402 LEE STREET
DECATUR, ALABAMA 35601
MAY 4, 2026

Council Chambers	**Regular City Council Meeting**	**6:00 PM**

DATE:	May 4, 2026
SUBMITTED BY:	Hunter Allen,Park and Recreation
ITEM TYPE:	Change Order
AGENDA SECTION:	RESOLUTIONS:
SUBJECT:	Resolution No. 26-106: Approve Wilson Morgan Rec Center OCO #8
FINANCIAL IMPACT:	NA

Decatur Parks and Recreation
Rec Center Change Order #8

GUARD POST ARRANGEMENT

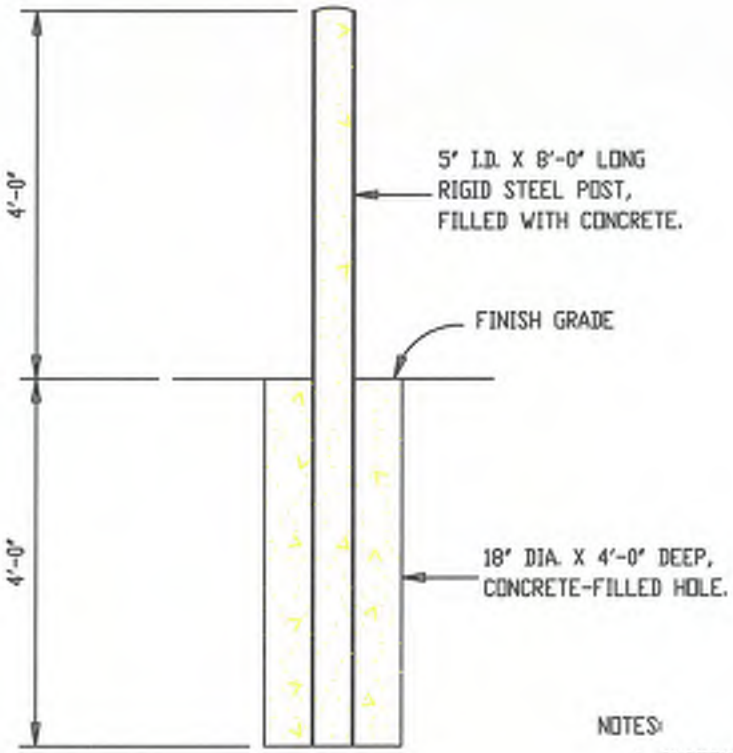
What is the reason for this change order?
Cost associated with furnishing and installing bollards at the Transformer Pad as requested by Decatur Utilities.

Reference: Added XFMR Bollards

A1 OVERALL FLOOR FINISH PLAN - MEZZANINE
GMC
DECATUR RECREATION CENTER
FINISH PLAN - MEZZANINE
OVERALL
A8.03

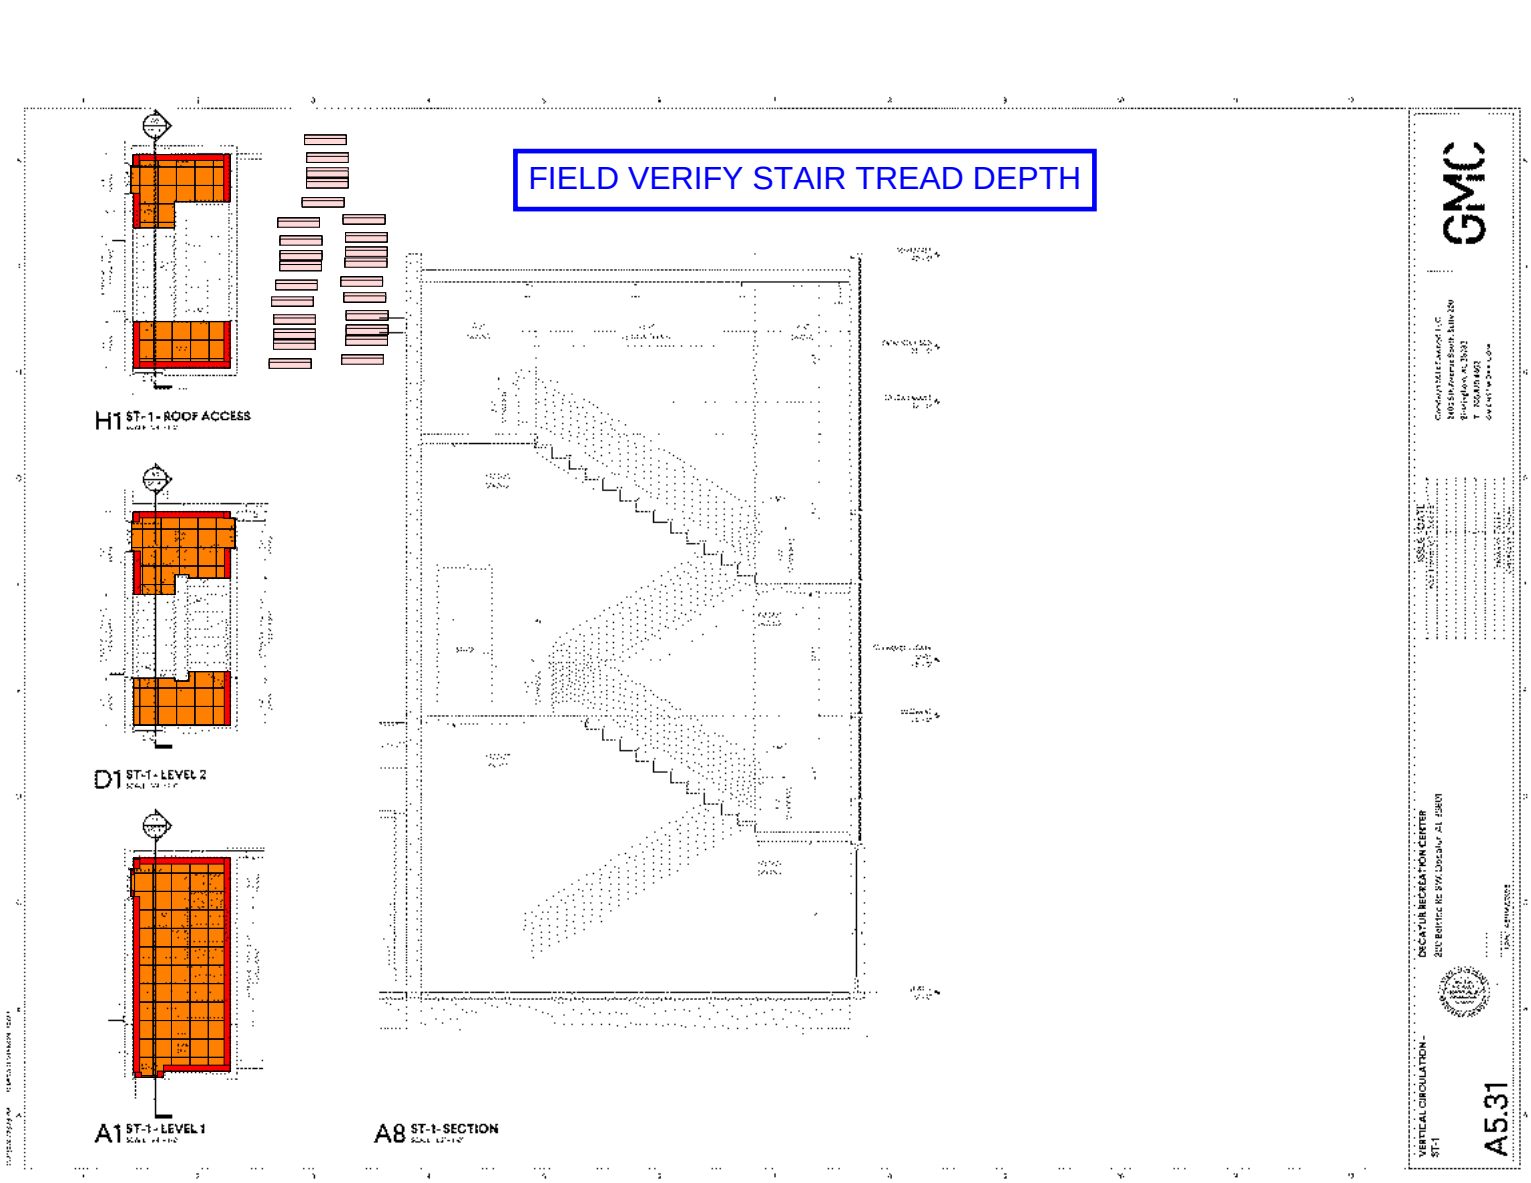
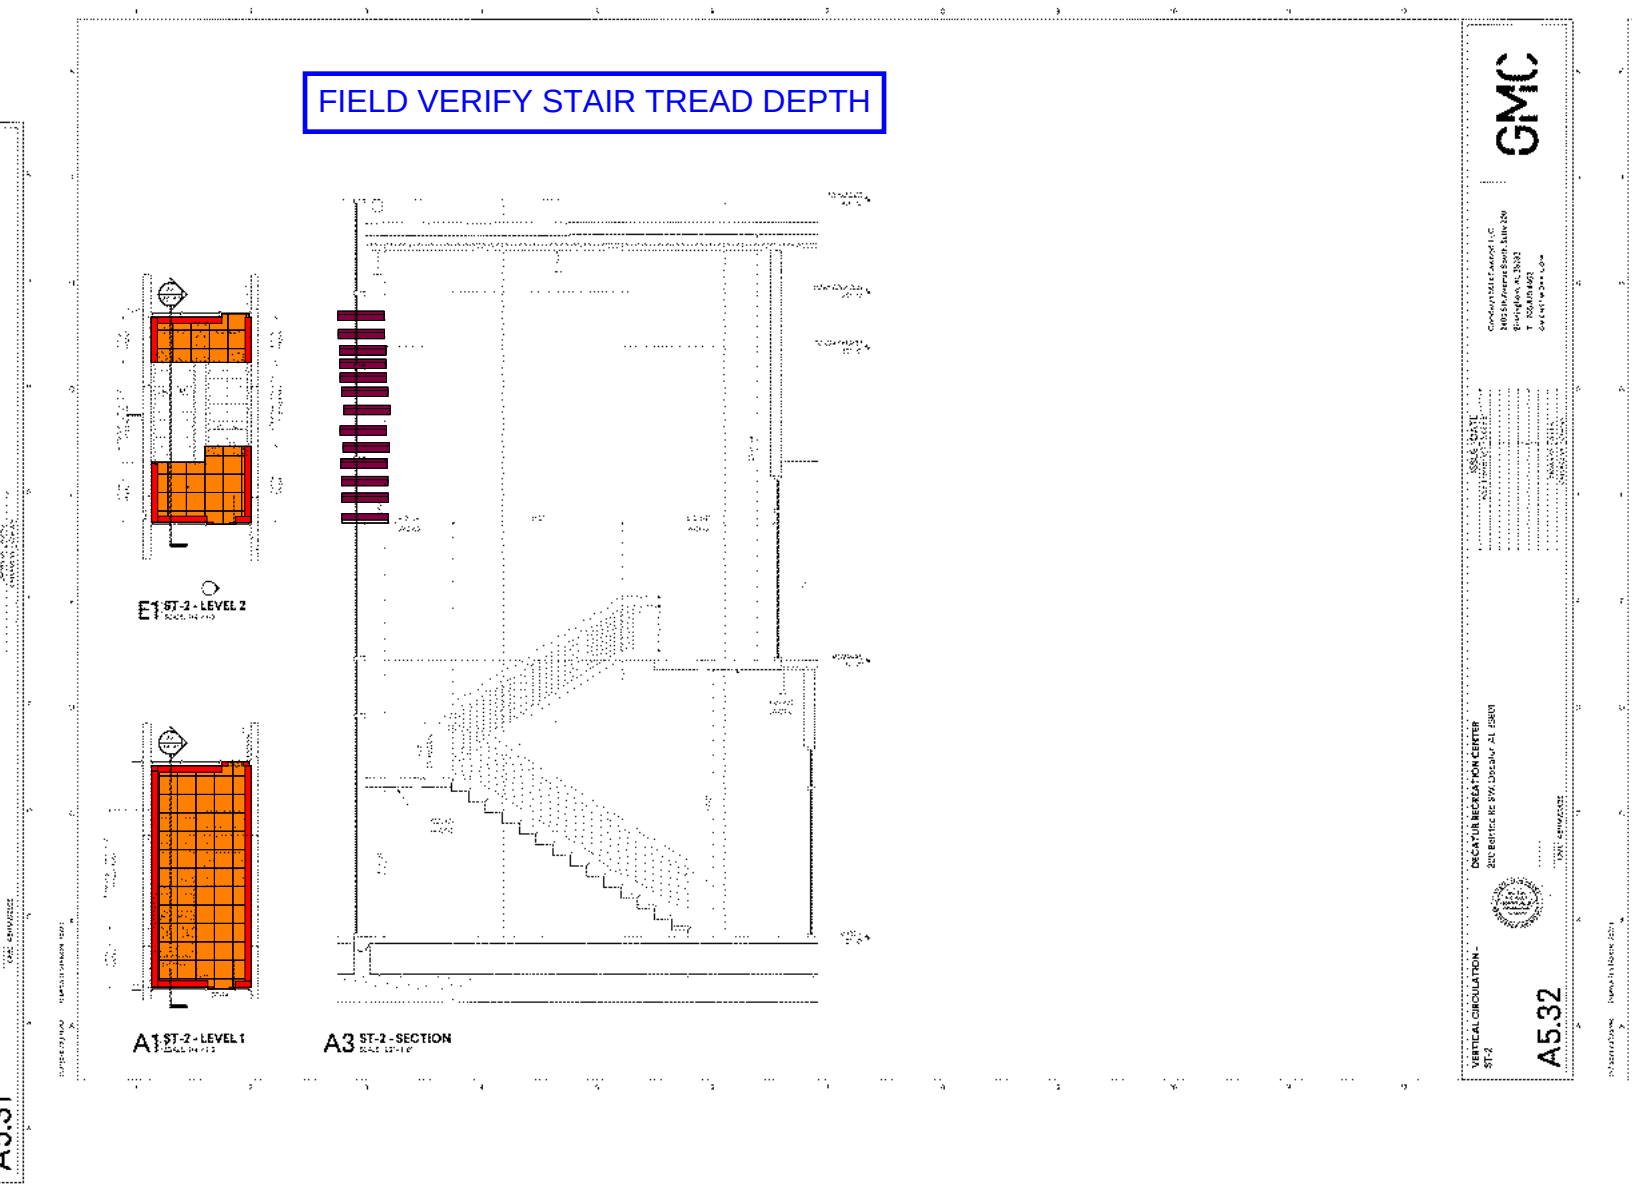
RF-1 Per ASI 27. Still TBD - CFC

Proceed with response from Interiors.
